BROOKHAVEN NATIONAL LABORATORY  
ASSOCIATED UNIVERSITIES, INC.

March 30, 1981

Mr. Mel Silberberg, Chairman  
Peer Review Group  
Fission Product Behavior Report  
U. S. Nuclear Regulatory Commission  
Washington, DC 20555

My following comments apply to both the Draft Report on Technical Bases for Estimating Fission Product Behavior During LWR Accidents and to the presentations and the comments made during the two-day review session.

Figure 1.7

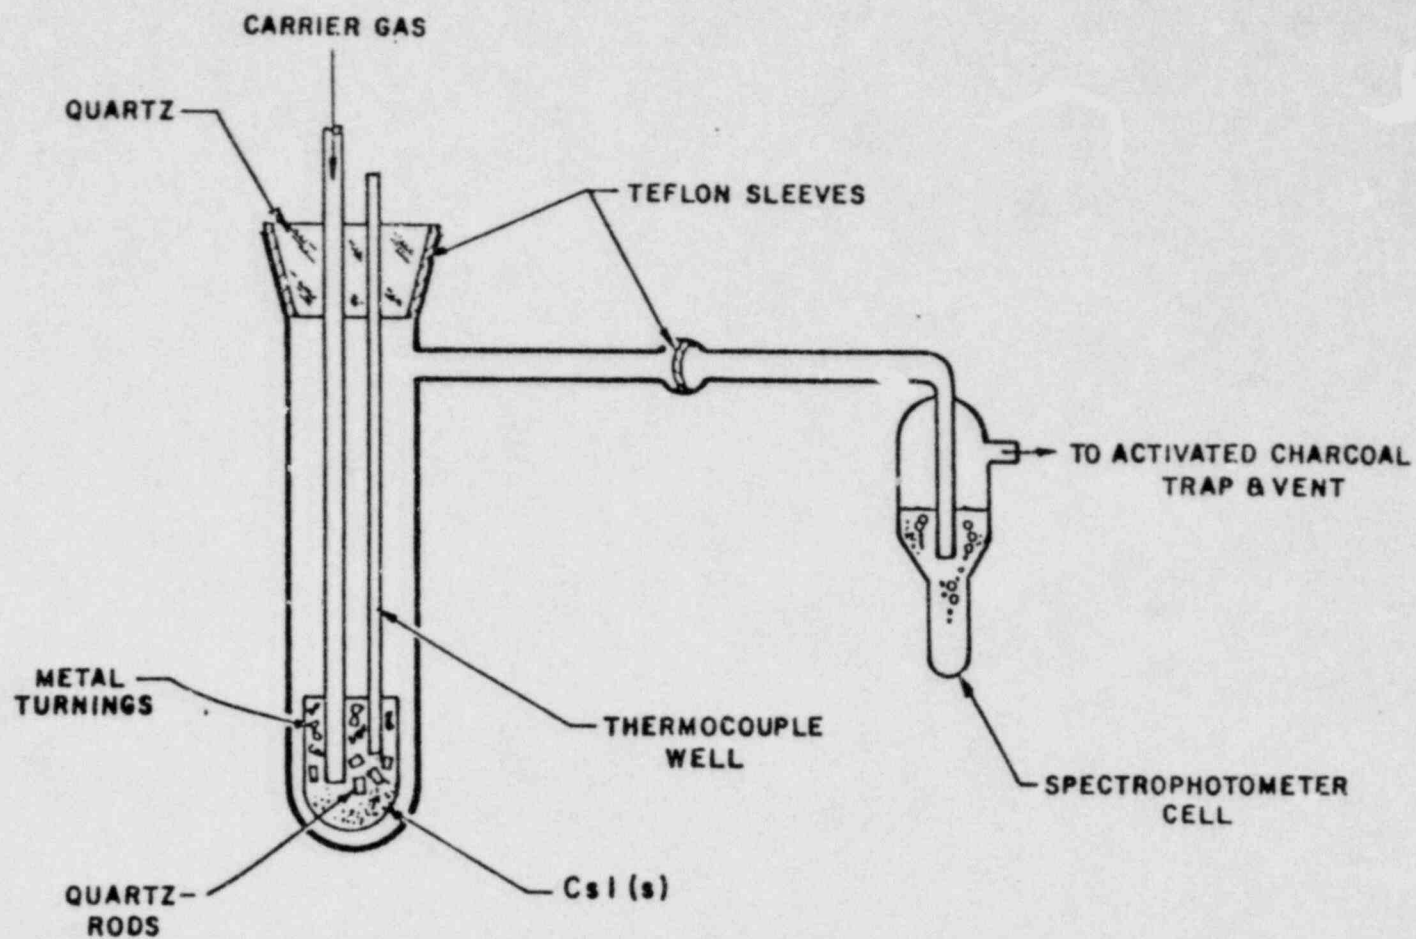
1978d) This unexpected result has prompted speculation on the source of iodine evolution and necessitated repeating the experiment. A schematic of the apparatus is shown in Figure 1.7. The result of the carbon steel/air/CsI experiment is shown in Figure 1.8. When air was replaced with pure O<sub>2</sub>, no effect on the rate of I<sub>2</sub> evolution was observed; however, when O<sub>2</sub> was replaced with He, the rate decreased substantially and probably would have reached a negligible level given sufficient time. The zero-order dependence of the rate on O<sub>2</sub> concentration is indicative of virtually complete reaction of the CsI or of a diffusion controlled reaction which is relatively independent of the O<sub>2</sub> concentration. The high rate of I<sub>2</sub> evolution confirms the previous result that CsI can attack carbon steel in the presence of O<sub>2</sub>. The reaction of CsI with high purity iron in the presence of O<sub>2</sub> is currently being investigated to elucidate the nature of the carbon steel reaction.

NO! Later experiments showed that CsI was actually attacking the quartz
